**From:** brooks anderson <brksanderson@gmail.com>  
**Sent:** Monday, October 16, 2023 12:50 PM  
**To:** Bell, Kathy M.  
**Subject:** Request to receive email of all notices regarding the Woods at Viewcrest applications

**Re: *The Woods at Viewcrest* · August 7, 2023 Request for Information (RFI)**

Re: ***The Woods at Viewcrest*** subdivision proposal  
**Applicant's 12/5/23 response to the 8/7/23 Request for Information (RFI)**  
➤ ***Is the Woods at Viewcrest Wetland Delineation Fundamentally Flawed?***

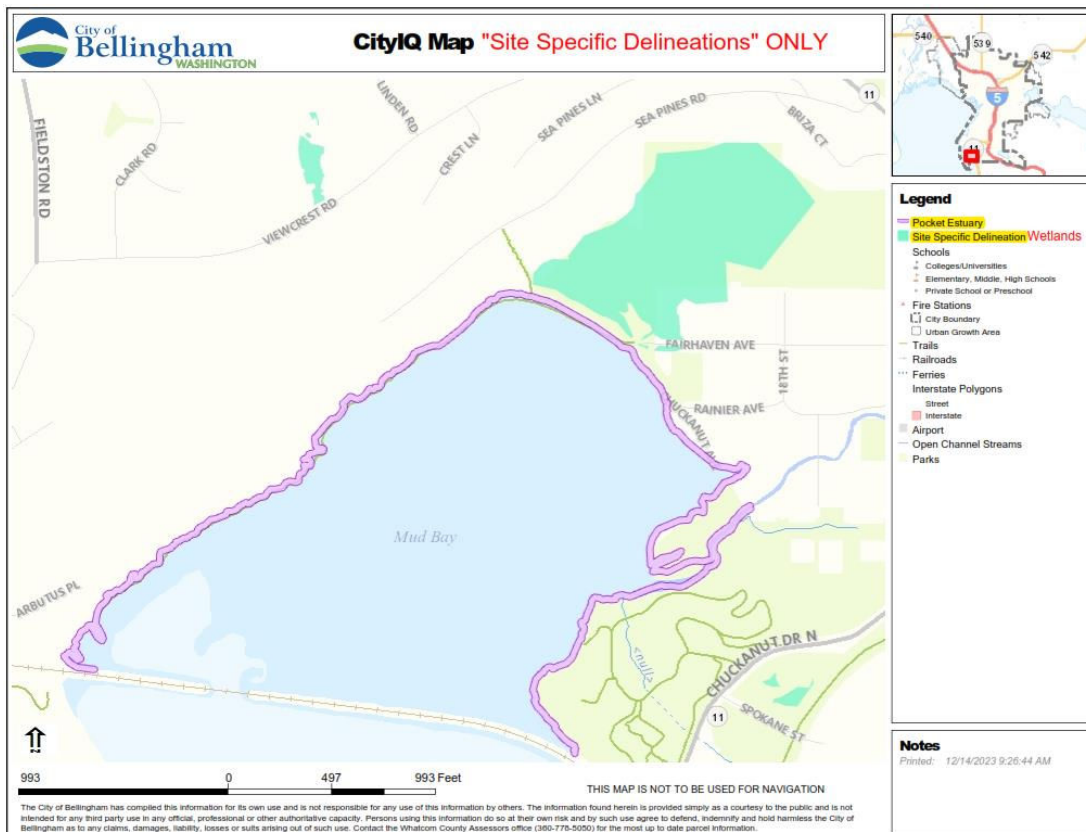
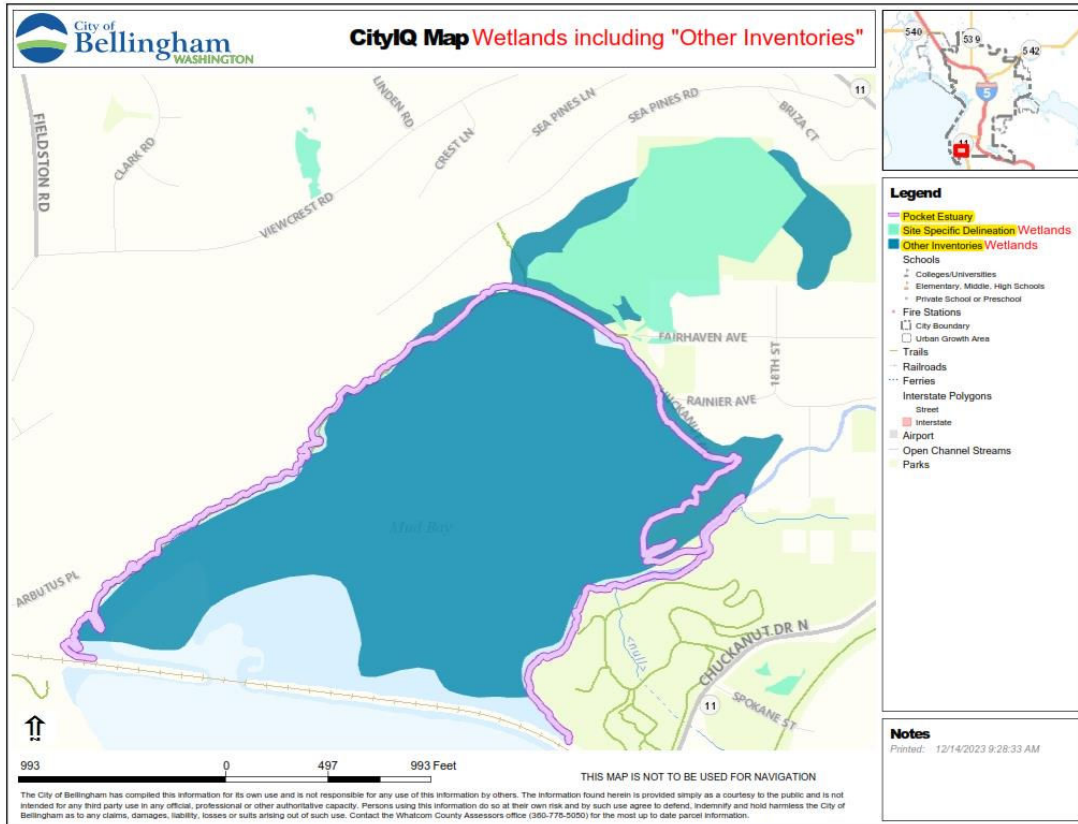
Although the City of Bellingham’s own CityIQ maps show Mud Bay as being distinct from Chuckanut Bay, the delineation refers to Mud Bay as Chuckanut Bay.

The NES wetland delineation recognizes the existence of estuarine wetlands throughout the entirety of Mud Bay (referred to as Chuckanut Bay) as identified by the USFWS NWI mapper. However, the delineation only considers a single “field-verified” estuarine wetland based solely on a CityIQ map, which includes only the *Site Specific Delineation* wetland layer. A more complete CityIQ map, which also includes the *Other Inventories* wetland layer, shows a solid zone of wetlands covering the vast majority of Mud Bay.

There is no indication that the NES wetland delineation attempted to confirm whether Mud Bay’s wetlands that were not “field verified” are, in fact, estuarine wetlands. Nor does the delineation acknowledge that Ecology has placed estuarine wetlands in a separate category because they are not conducive to field verification and, therefore, would not be included on a map of site specific delineated (i.e. “field verified”) wetlands.
